FINAL REPORT
ON THE SITE INVESTIGATION
OF THE
CAPITOL ENGINEERING PROPERTIES
AT
724 EAST SOUTHERN PACIFIC DRIVE
AND
415, 419 SOUTH 7TH STREET,
PHOENIX, ARIZONA

Prepared by:
WATER RESOURCES ASSOCIATES, INC.
2702 North 44th Street, Suite 101-B
Phoenix, Arizona 85008

June 9, 1989

ATTACHMENT I
RESPONSES TO ADEQ COMMENTS

FIGURE 1

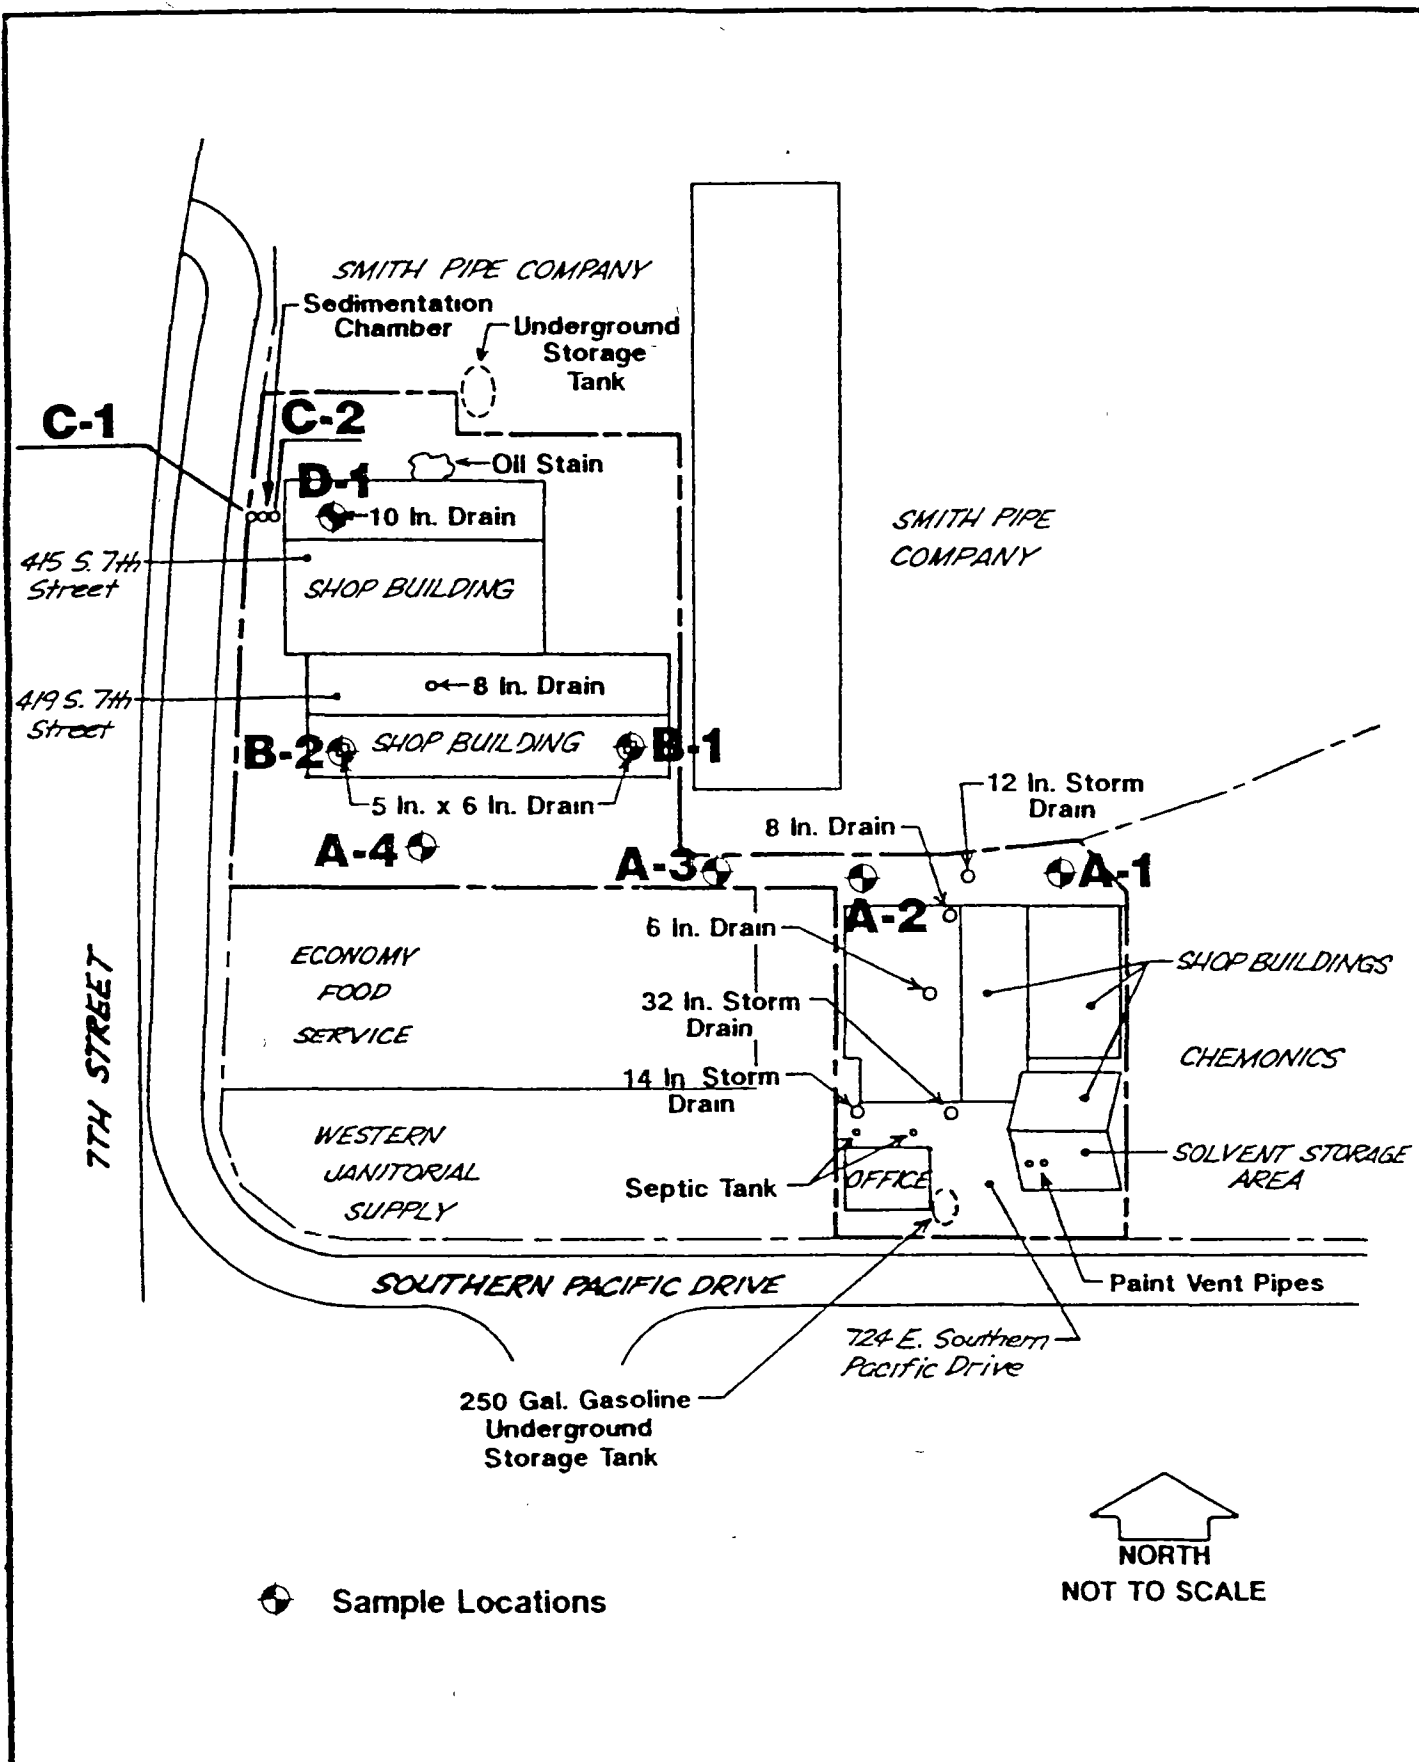
Is the septic tank still in use? What was the improvement? What is it used for?

Based on communications with Mr. David Porter of Capitol Engineering, the improvement does not regard the septic system but the construction of an additional drain (14-inch drain) for stormwater runoff collection (see Figure 1). This drain was located near the existing septic systems. The septic system at 724 East Southern Pacific Drive is still in use and serves two toilets, one located in the office and one in the shop building.
